Re: Docket No. 2015-02: Antrim Wind Energy, LLC – First Supplement to Application Appendices

Please find enclosed for filing with the New Hampshire Site Evaluation Committee in the above-captioned matter, an original and eighteen (18) copies of the Applicant’s First Supplement to the Application Appendices. The First Supplement includes an updated septic plan, which reflects a modification to the septic plan included in Appendix 2F of the Application. Appendix 2F contains the Individual Sewage Disposal System (“ISDS”) application and the First Supplement modifies page 10 of the ISDS application.

PROPOSED SEPTIC SYSTEM

ANTRIM WIND ENERGY, LLC
ANTRIM WINDPARK
ANTRIM NEW HAMPSHIRE

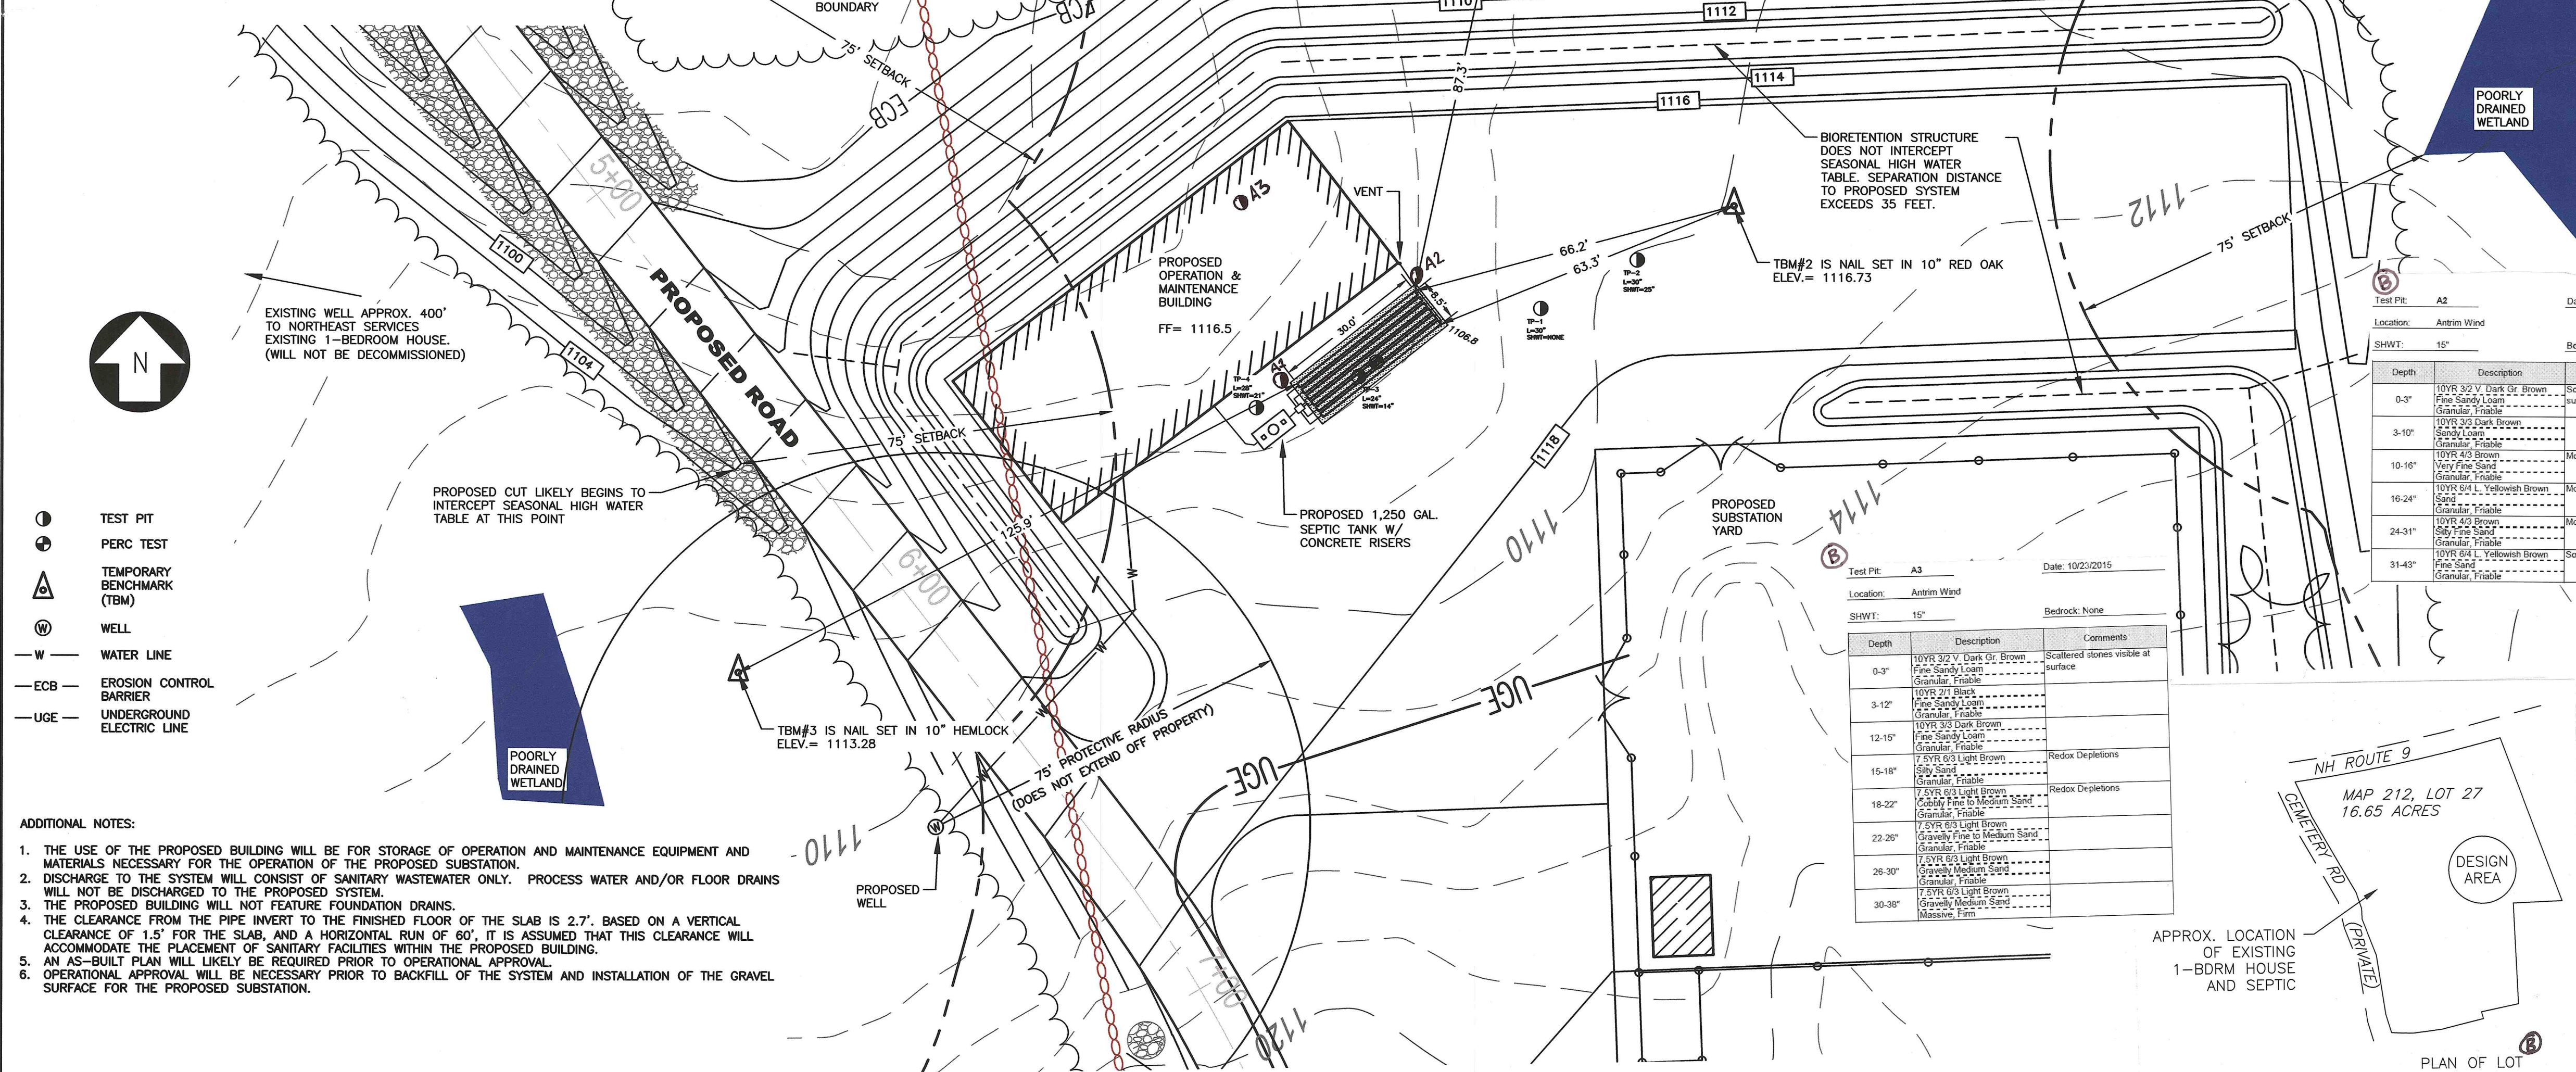
NO.	REVISION	DATE	BY	CK	P.E. STAMPED BY	P.E. No.
A	INITIAL SUBMISSION	1/18/12				
B	Add Test Pits, Update Lot Size, etc.	10/30/15	DMP
